**CHAPTER 11**  
**REQUEST FOR WAIVER FROM ACCESSIBILITY REQUIREMENTS**  
**CHAPTER 553, PART V, FLORIDA STATUTES**  
**August 1999**

MODIFICATION PER  
ADA CODE REQUIREMENTS  
CHANGE OF USE

**SLIP N' SLIDE RECORDS**  
919 4TH STREET  
MIAMI BEACH, FL 33139

DRAWING No.  
10-2504 A-1  
SHEET  
A-3

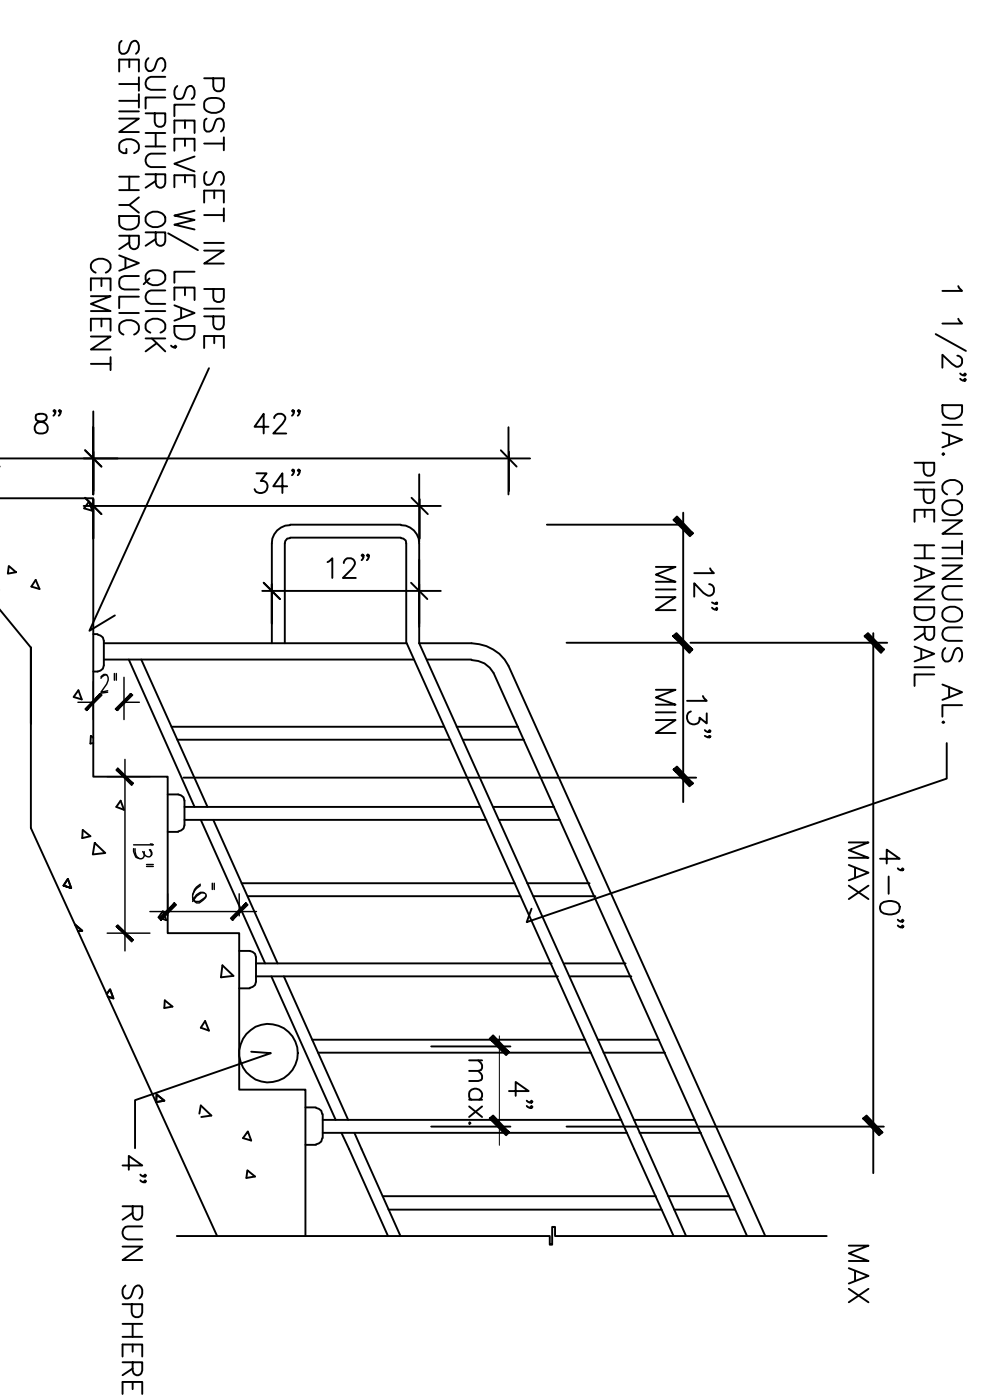
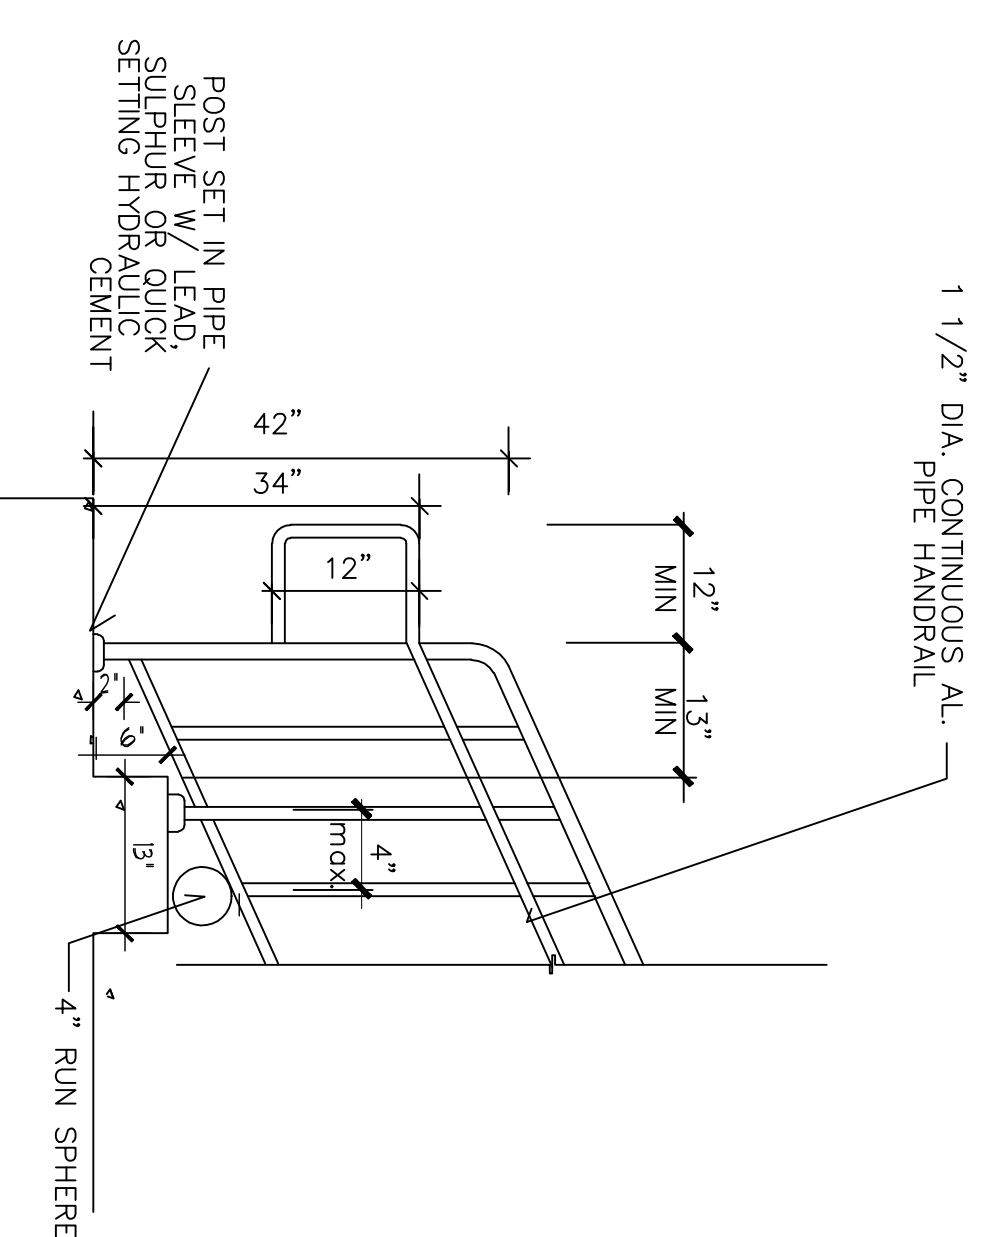
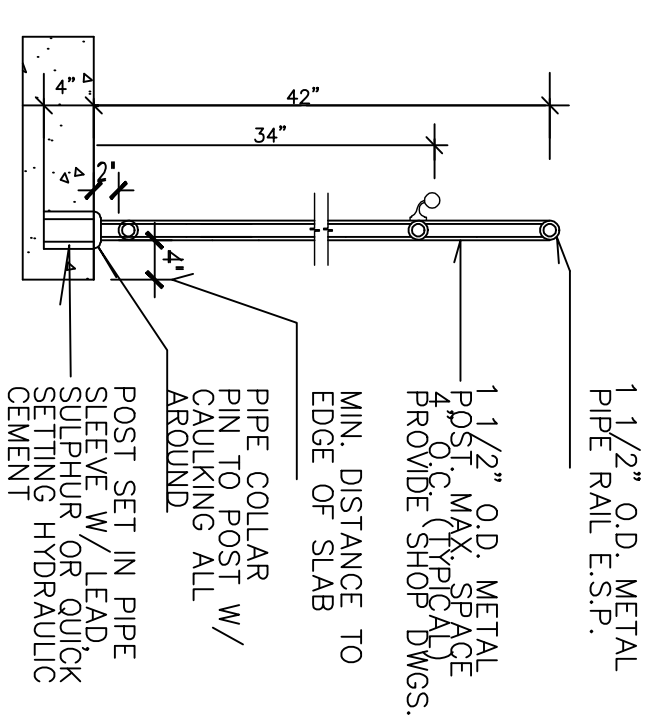
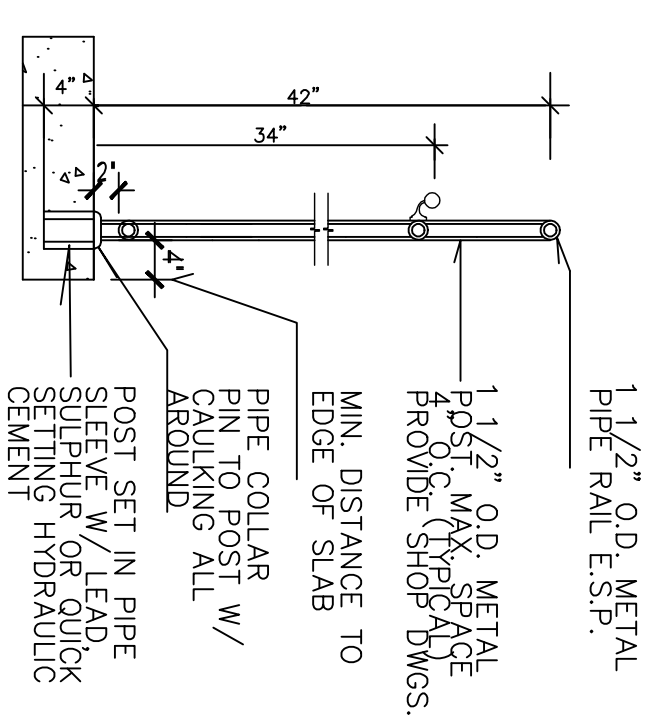
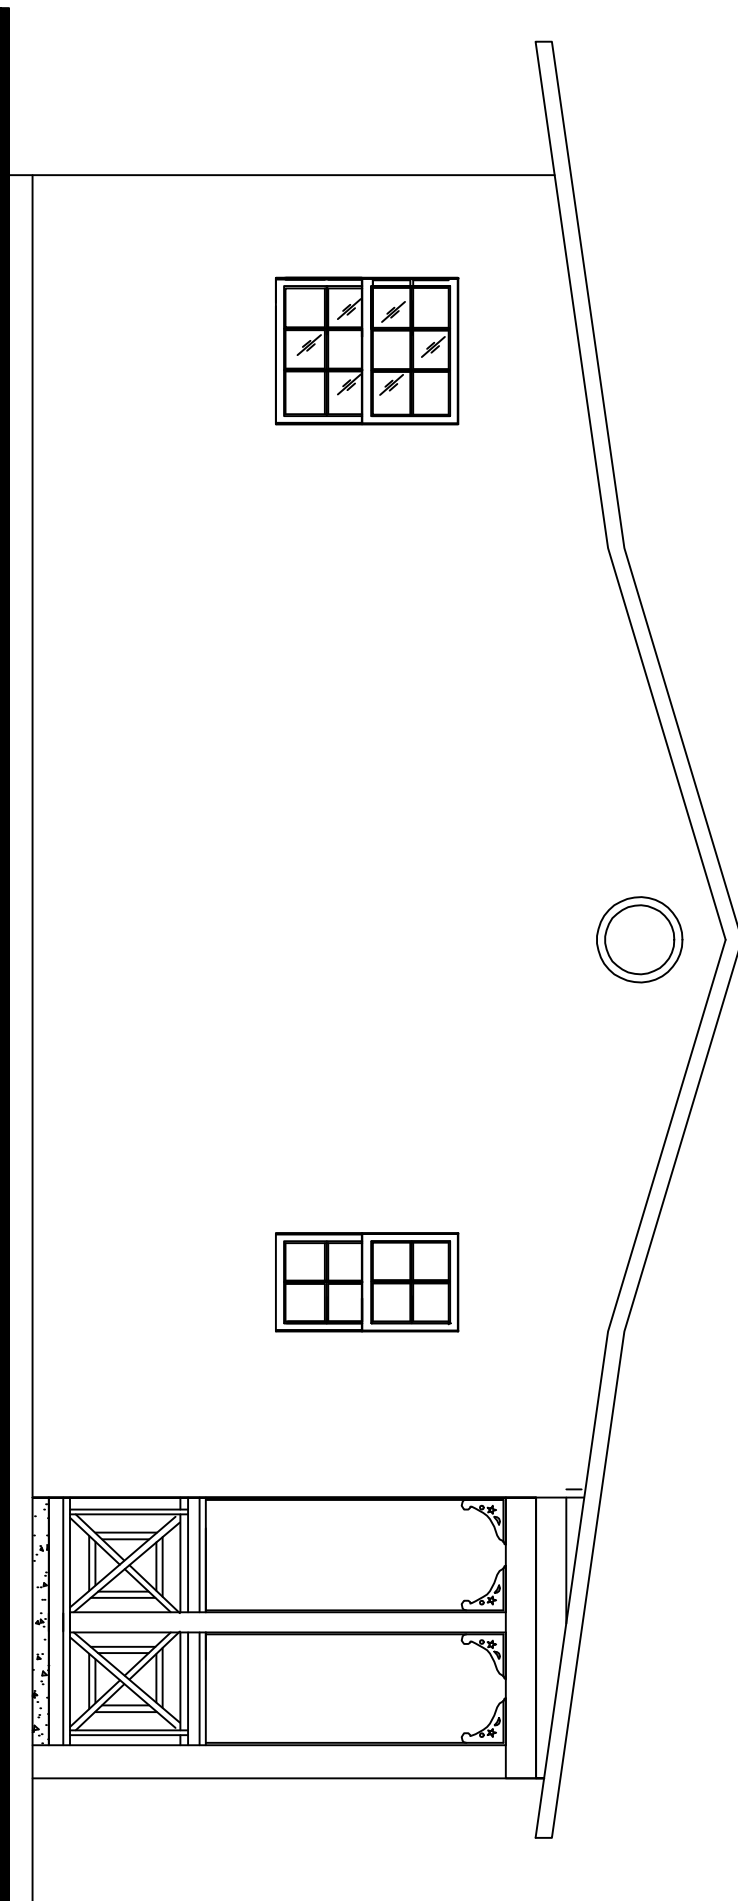
SHEET A-3:

1. PLANS SHOW ON A-3 THE HANDRAIL/GUARDRAIL DETAIL, THE REJECTION OF THE LAST STRINGER TO THE TREAD SHALL BE 6"

2. PROVIDE DISTANCE OF HANDRAIL FROM THE GUARDRAIL PER THE FFPC 07 ED CHAP 7, RECTIFY
3. MAKE CROSS REFERENCE FOR EACH STEP, HANDRAIL, GUARDRAIL FOR THIS PROJECT, NOT JUST A TYPICAL AS SHOWN ON A-3
